Access Compliance Report

Public Rights-of-Way

(Curb Ramps)

Intersection ID: 10018526	Main Street: MARYANNA_CT	Cross Street: N/A	Location: W
ADA ID: F14D3B1053BD	Ramp Type: Perp	Initial Pass/Fail: Fail	Overall Compliance: No
Severity Score: 21.25			
Codes/Mitigation Info/Possible Solution		Field Measurements/Component Compliance

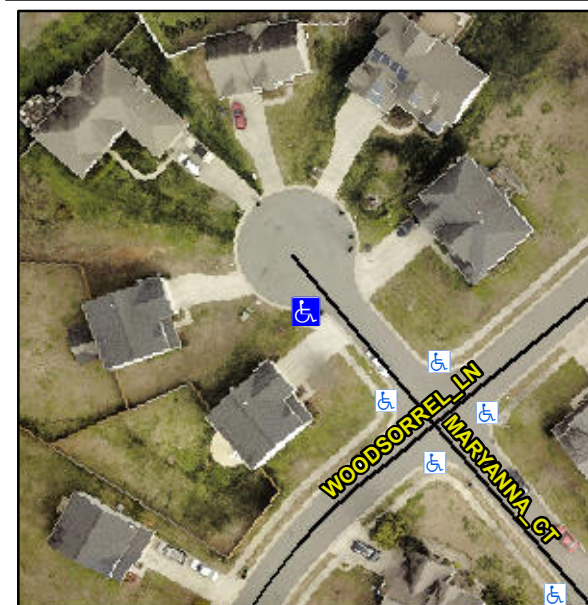
Not Found, R304.5.1, R304.5.3

Compliance	Description	Data	Compliance	Description	Data
N/A	Ramp Length (in)	48.0	Yes	Ramp Slope (%)	5.0
No	Ramp Width (in)	47.0	No	Ramp XSlope (%)	5.9
N/A	Flare Type LT	N/A	N/A	Flare Type RT	N/A
N/A	Flare Slope LT (%)	N/A	N/A	Flare Slope RT (%)	N/A
N/A	Flare Traversable LT?	N/A	N/A	Flare Traversable RT?	N/A
N/A	Landing Length (in)	N/A	N/A	DWS Provided?	N/A
N/A	Landing Width (in)	N/A	N/A	DWS Contrast?	N/A
N/A	Landing Slope (%)	N/A	N/A	DWS Length (in)	N/A
N/A	Landing X Slope (%)	N/A	N/A	DWS Full Width?	N/A
N/A	Landing Curb? (Y/N)	N/A	N/A	DWS Offset (in)	N/A
N/A	Shared Landing?	N/A			
N/A	Gutter Ponding?	Yes	N/A	Gutter Slope (%)	N/A
N/A	Gutter Lip Ht (in)	N/A	N/A	Gutter X Slope (%)	N/A
N/A	Painted X Walk1?	No	N/A	Painted X Walk2?	N/A
	X Walk 1 Direction	To E		X Walk 2 Direction	N/A
N/A	X Walk 1 Width (in)	N/A	N/A	X Walk 2 Width (in)	N/A
	X Walk 1 Slope (%)	6.0		X Walk 2 Slope (%)	N/A
	X Walk 1 X Slope (%)	4.5		X Walk 2 X Slope (%)	N/A

Remove & Replace Entire Ramp.
